**TO: ALL BIDDERS UNDER RFQ No. 20-3003740, South River Trail Boardwalk Repair**

**ADDENDUM NO. 1**

**Request for Quote (RFQ) No. 20-3003740 South River Trail Boardwalk Repair** is hereby amended as follows:

**DESIGN DATA**

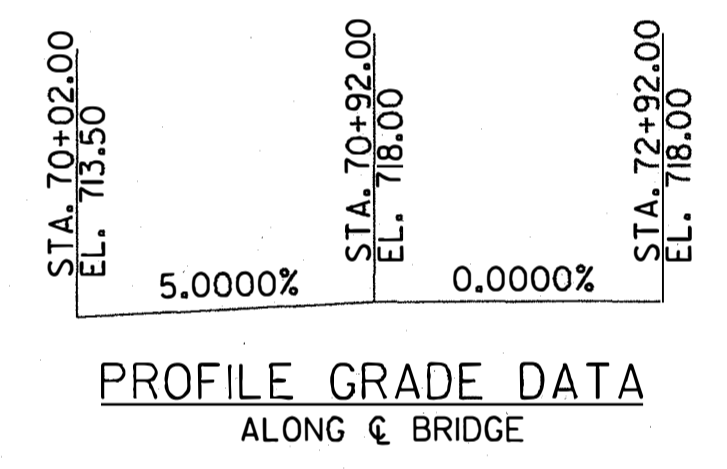
D. **Question:** Is there a known weight capacity on the boardwalk?

*Answer: See attached plans.*

TYPICAL DETAILS 1

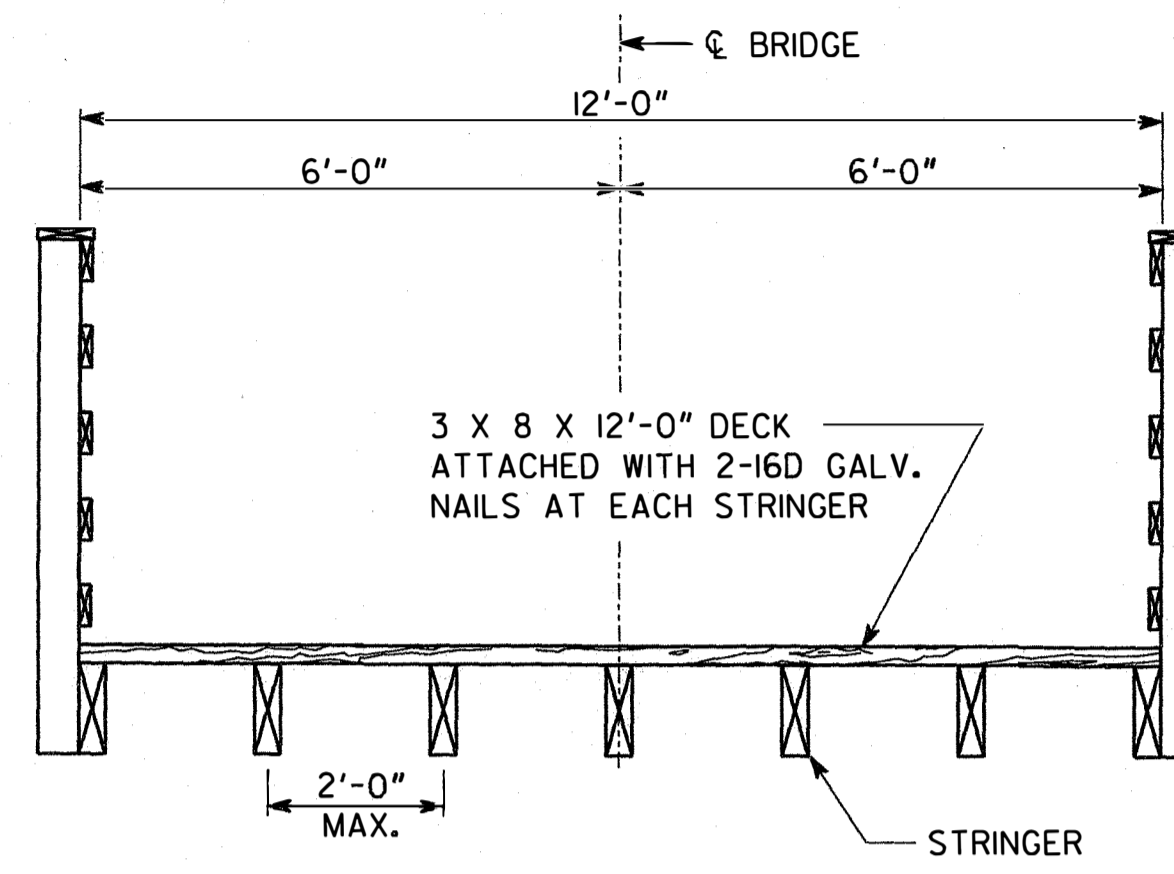
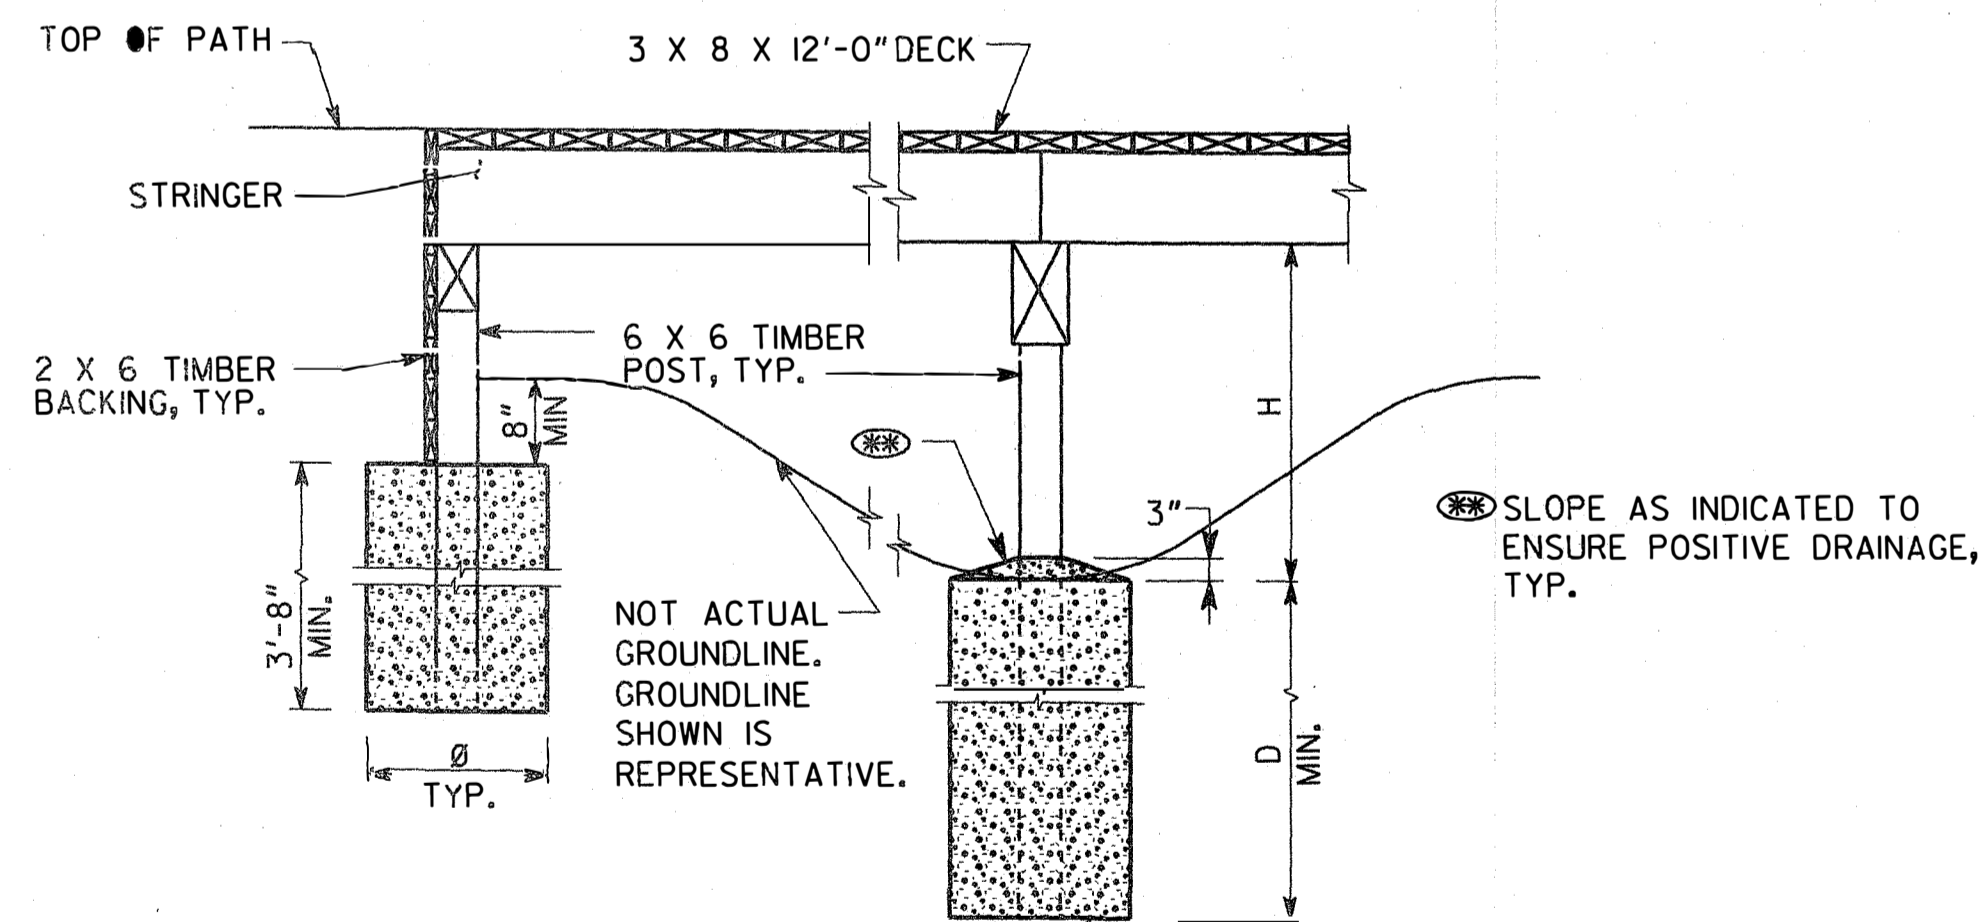
C. **Question:** Do you have a detail of the existing boardwalks construction so that we might be able to review what the substructure looks like, and how many stringers we'll need to attach to?

*Answer: See attached plans.*
